Public consultation on the revised wind energy development guidelines

Joint consultation response prepared by the following group of acousticians:

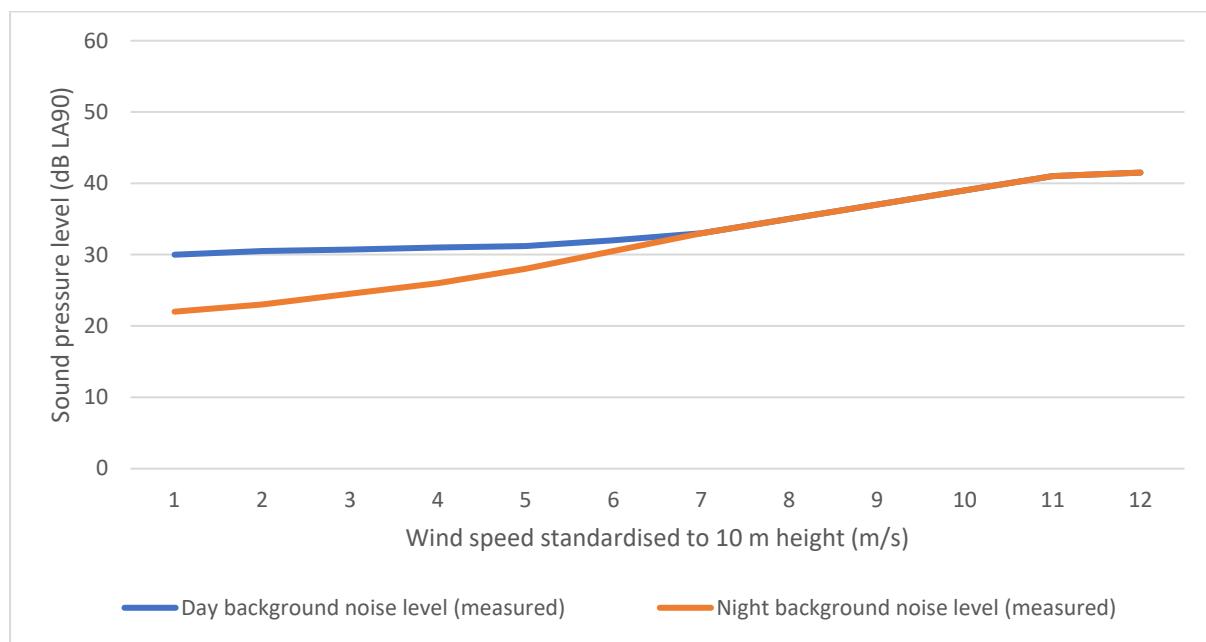
- 3.7.8 As discussed below in relation to SACs, contamination from sources other than the wind turbines, which is a definite possibility when considering internal noise measurements at low frequencies, could lead the proposed criterion to appear being exceeded. The draft guidelines do not make this sufficiently clear.

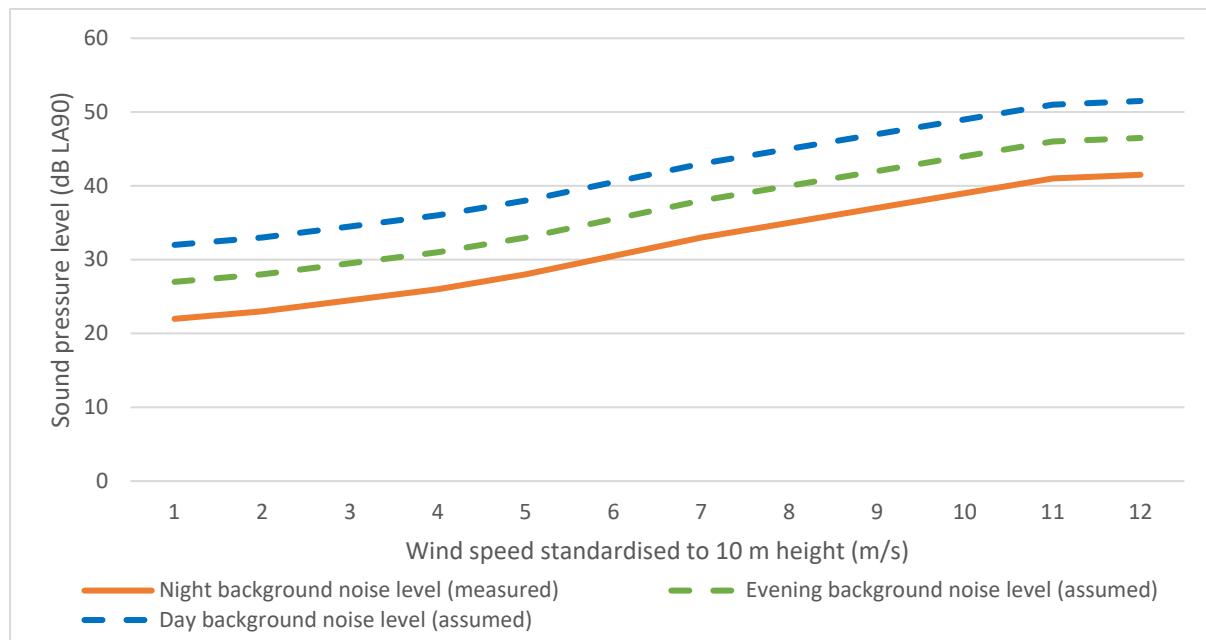
- 3.7.9 It is assumed that LFN noise limits are set out in Table 4.1 of the draft guidelines are meant to replicate the criterion curve in the NANR45 documents; however, the criterion curve in NANR45 uses L_{eq} as the noise metric, whilst Table 4.1 refers to L_{90} , which is incorrect. If L_{90} is to be used, how this L_{90} criterion was formulated and how it would be assessed needs to be specified. The first report notes that:

- 3.7.10 It is unclear if the permitted relaxation of criteria during day-time periods in NANR45 should be applied or not. Although this is referred to in the text of the draft guidelines it is not apparent in Table 4.1.
